**Electric motor-operated hand-held tools, transportable tools and lawn and garden machinery – Safety –
Part 3-1: Particular requirements for transportable table saws**

AMENDMENT 1

Amendment 1 to IEC 62841-3-1:2014 has been prepared by IEC technical committee 116: Safety of motor-operated electric tools.

Figure 114 – Minimum distance from the front edge of the table top to the front edge of the saw blade guard

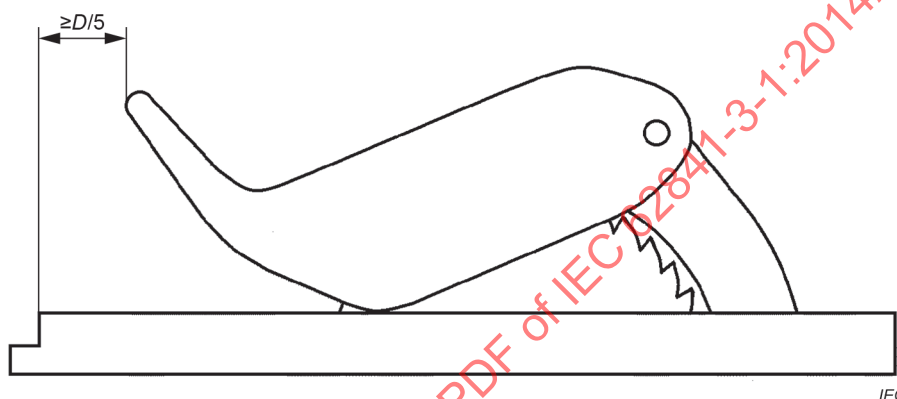
Replace the existing Figure 114 with the following new figure:
